## Major Comments:

1. **DEC Comment: Ribbed Mussels.** [Note: The overall text of DEC's comment on Ribbed Mussels contains a number of specific points to which DEP has responded below. The specific points in DEC's comment, as identified by DEP, are highlighted in the text below, and provided with a superscript letter that keys to the specific DEP response.] Under the selected alternative, the City has proposed construction of ribbed mussel beds in both Bergen and Thurston Basins to reduce bacterial load from CSOs and storm water discharges to these waterbodies. Ribbed mussels have not been considered under any other LTCP and represent a novel yet unproven technology. The ribbed mussel beds are the primary component of the selected alternative that will be used to reduce bacterial loads to both Basins (the other components have no or negligible impact on water quality) and the analysis presented in Appendix D assumes that the ribbed mussels will remove 10 percent of the bacterial load in the waterbodies. Based on that assumption, attainment levels in the Basins for the fecal coliform water quality standard will improve by up to 5 percent on an annual and recreational season basis.

### **Microcosm Bench-Top Experiments**

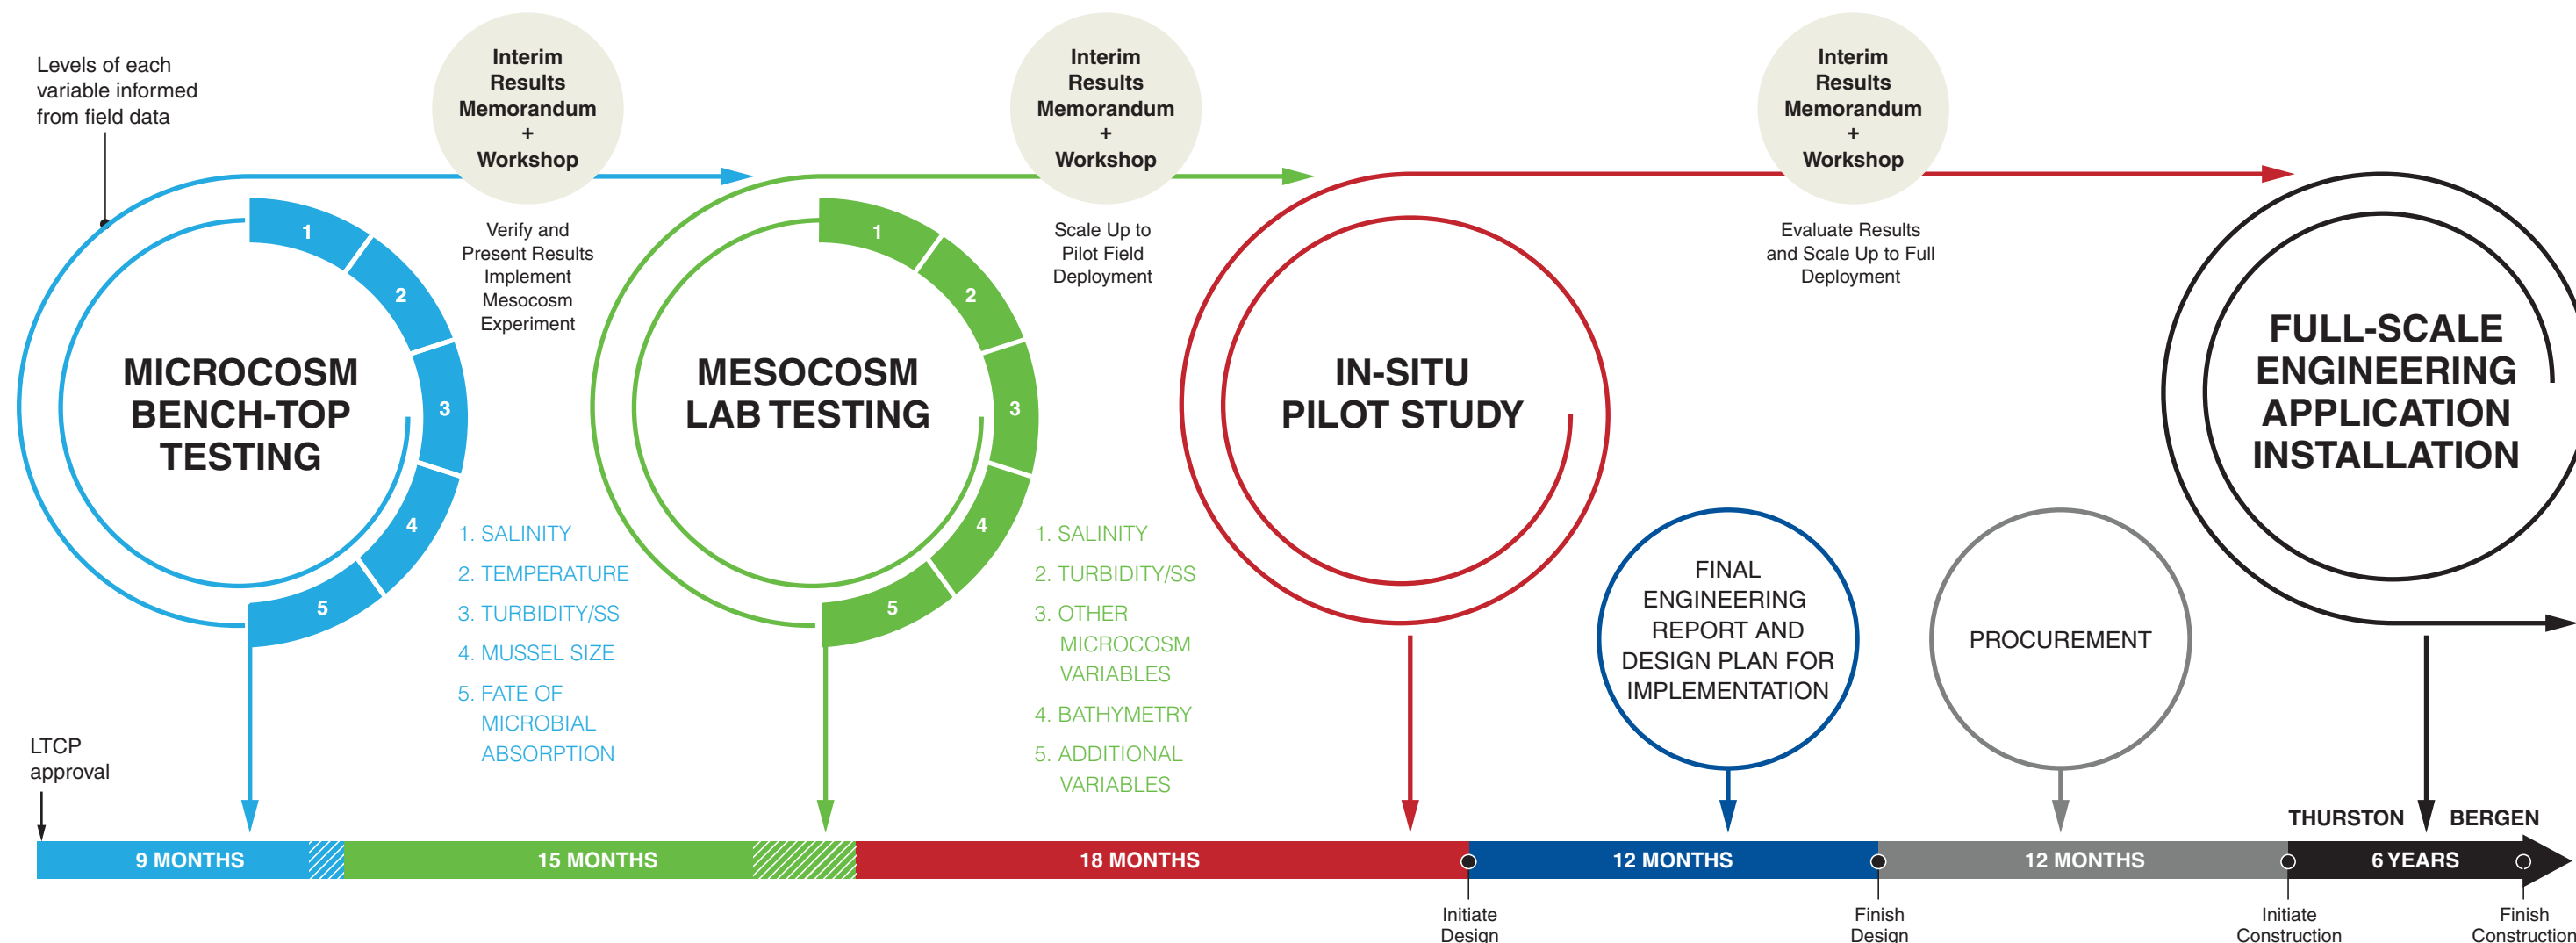
As highlighted by DEC, "the City needs to include a plan to undertake a series of experiments and studies that will gradually build upon each other and establish a solid basis for the design of a full-scale engineering application of ribbed mussels for improving water quality in Bergen and Thurston Basins." Accordingly, DEP is proposing a comprehensive series of experiments guiding the scale up towards a full-scale deployment of ribbed mussels in Bergen and Thurston basins. These series of experiments consist of additional microcosm experiments (bench top tests), mesocosm experiments to simulate field conditions, and an in-situ pilot study as recommended by DEC. Data and results gathered from these studies will be used to shape the design of the full-scale engineering application. **Figure 1** presents the overall plan, sequencing, and expected outcomes from the laboratory to the field. **Throughout this process, regular meetings and workshops will be scheduled with interested stakeholders and DEC so that decisions are made collaboratively.**

Additional microcosm experiments would be conducted prior to and in concurrence with mesocosm experiments to study the effects of individual variables on the filtration capabilities of ribbed mussels (see **Table 2**). These variables include:

### **In-situ Pilot Study**

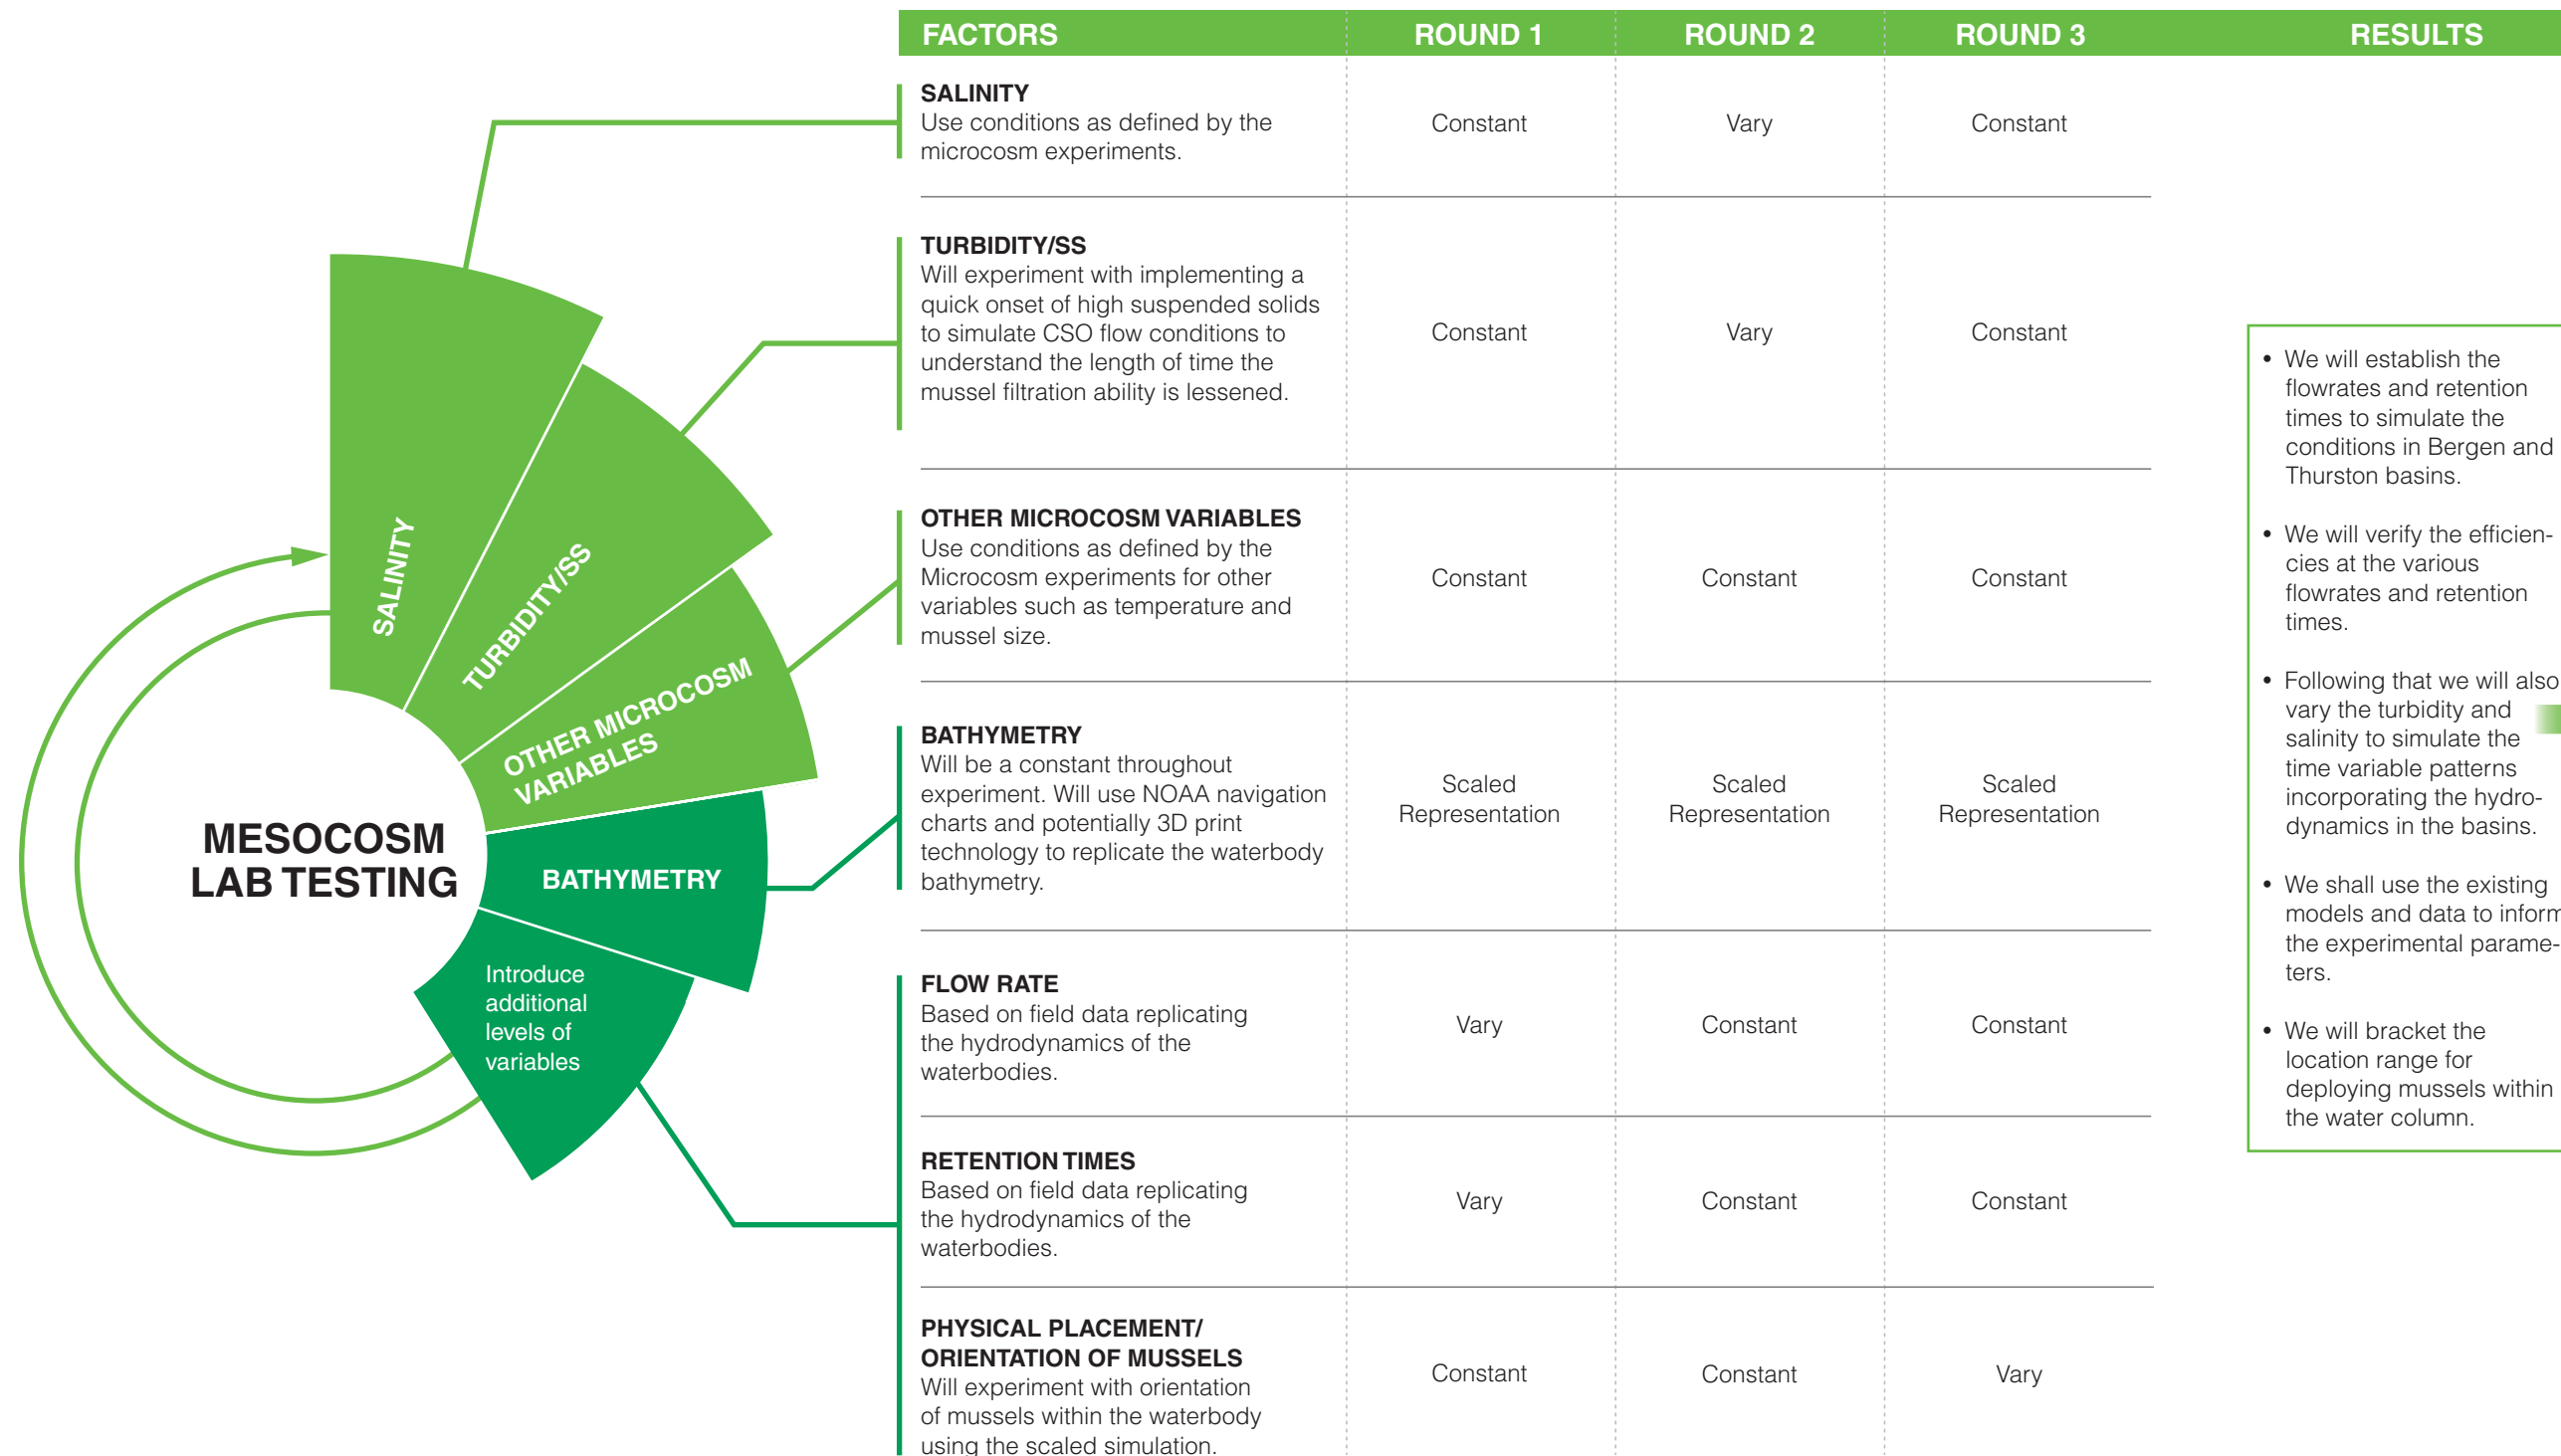
- <sup>D</sup>Following bench-top and mesocosm-level experiments, the City must undertake an in-situ pilot study (in accordance with all applicable laws and regulations). The in-situ study should be used to identify the key design factors that influence the performance of the mussel beds in filtering the targeted bacteria, including location within the waterbody, design of the placement of the mussels, mussel size and filtering capacity, waterbody retention times, existing water quality and particulate size, types of bacteria encountered, and mussel survivability and die off over time. The results from the various experiments and studies should be used to further develop appropriate models to represent the mussels and these models should be peer reviewed.

*The next phase of experimental testing toward final design would be to design an in-situ pilot study (see **Figure 4**). The primary objective of the in-situ pilot study would be to replicate and verify the filtration rates and bacterial removal rates achieved in the mesocosm (lab) testing in Bergen and/or Thurston basins. Based on the prior mentioned literature review, experimental flow-through systems or other similar installations will be evaluated to isolate the inflow and outflow to test for removal efficiency and would include parallel setups within the aforementioned basins as well as control setups with no mussels. These parallel setups with isolated inflow and outflow would provide verifiable results and a much better understanding of the quantifiable water quality benefits that can be scaled up to represent the*

# Figure 5 – Southeast Queens Spine Prioritization

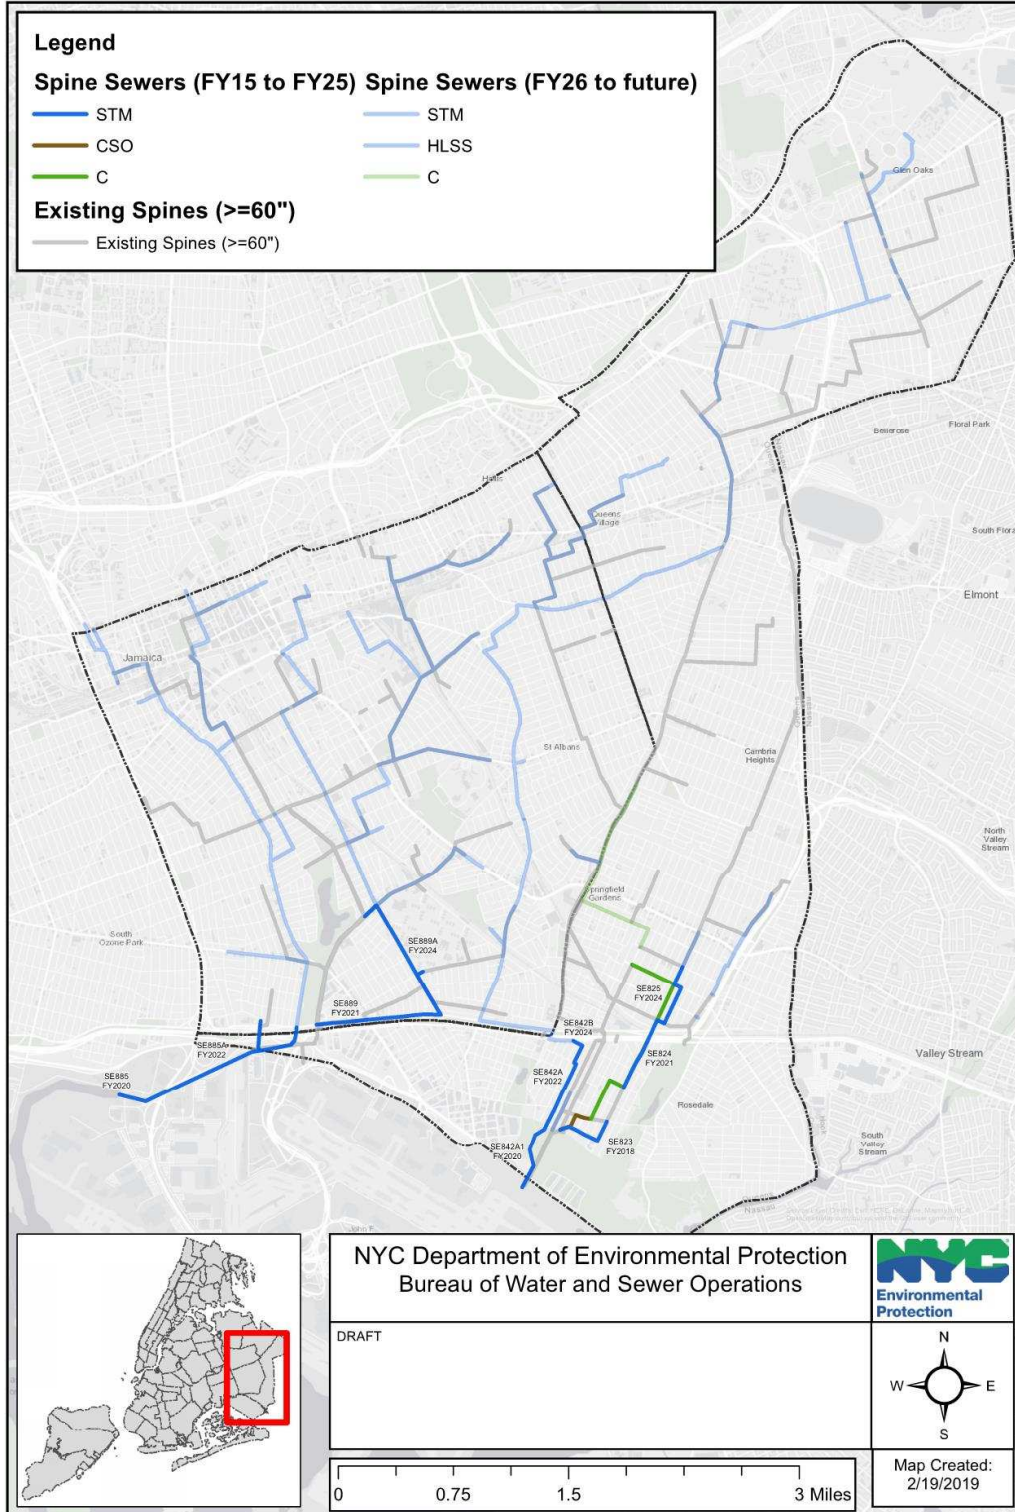
*As requested by DEC, conceptual modeling is being developed for the purposes of simulating the changes in CSO and stormwater volume discharges to Thurston and Bergen Basins upon completion of the SEQ storm sewer buildout. The landside modeling results will be incorporated into the water quality model to assess the potential impacts to water quality attainment. Tables, figures and commentary summarizing the findings of this evaluation will be provided in the Supplemental Document.*

The current 10-year capital plan primarily consists of the construction of major storm sewer spines illustrated in **Figure 5** and neighborhood projects to address localized flooding. No collector storm sewer connections will be made to the major sewer spines under the current 10-year capital plan. Collector sewers will be developed under future phases and are not shown in **Figure 5**. At this point in the project planning, it is not known when the new spines will be activated. The HLSS proposed for the Springfield/Laurelton Area is similarly not included in the current 10-year capital plan, as downstream infrastructure must be constructed first, to accommodate the storm flow to be diverted from the combined sewer system to the new storm sewers.

**Figure 6 – JAM-005/007 Outfall Disinfection Alternative**

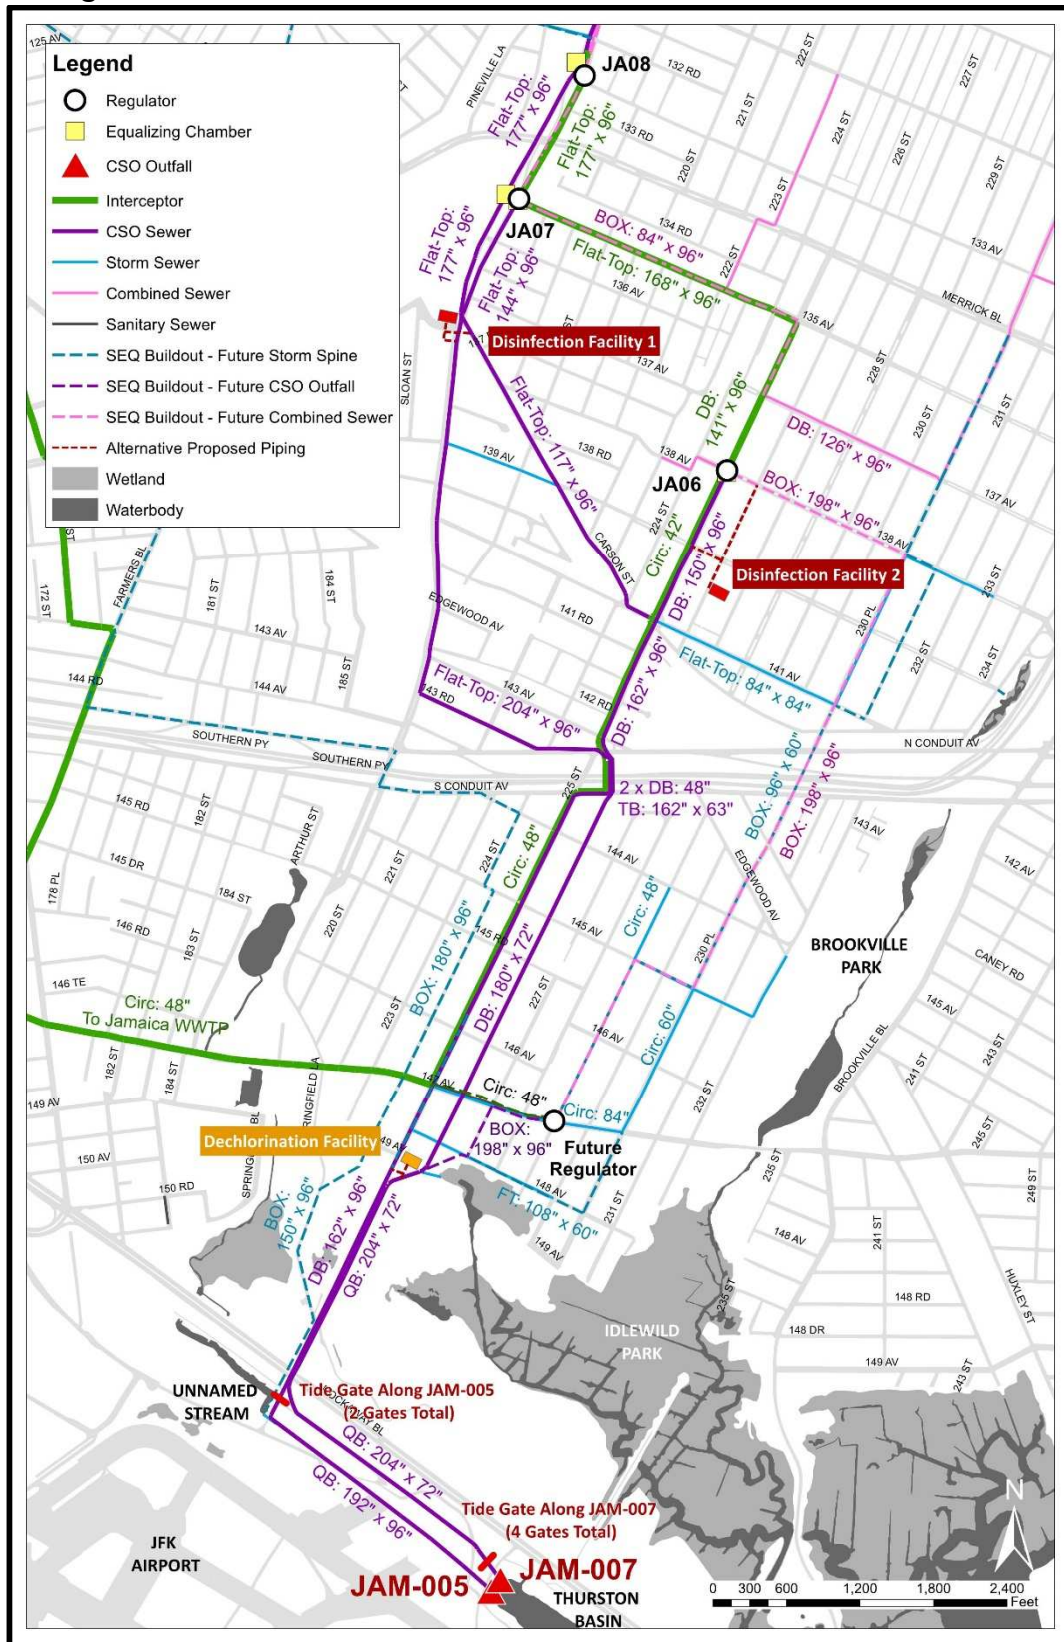
*In consideration of the highly variable operating conditions, successful operation of an outfall disinfection system for Thurston Basin would be extremely complicated and pose a high risk of not consistently achieving permit limits. As a result, outfall disinfection is not considered to be feasible for Thurston Basin.*

**Figure 6** *provides a scaled map of the collection system downstream of Regulators JA-06, JA-07 and JA-08. The figure identifies over a dozen interconnections (48" or larger) contributing CSO and stormwater to the multiple barrel CSO Outfalls JAM-005 and JAM-007. In addition, numerous smaller connections (not shown in the figure) exist along each of the outfalls. Due to the configuration of the collection system, siting of*
